REFERENCE	BT_2015_FR20_1_UK
DATE	March 3rd, 2015
SUBJECT	Headrest pin strip, 2015 engine mapping, new oil pressure sensor, steering wheel quick release
PART	Headrest, ECU, Oil pressure sensor, steering wheel quick release

*ECU release 2015.1 sticker*

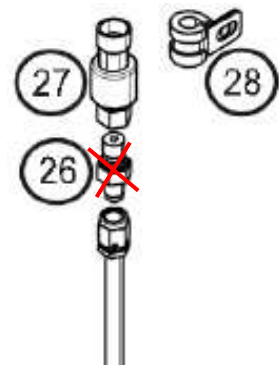
All FR2.0 ECUs must be reprogrammed by Renault Sport Technologies for the 2015 season with these new ECU software and mapping, release called **2015.1**, following the program schedule detailed later on. The reprogrammed ECU will then be identified by the related sticker as shown below
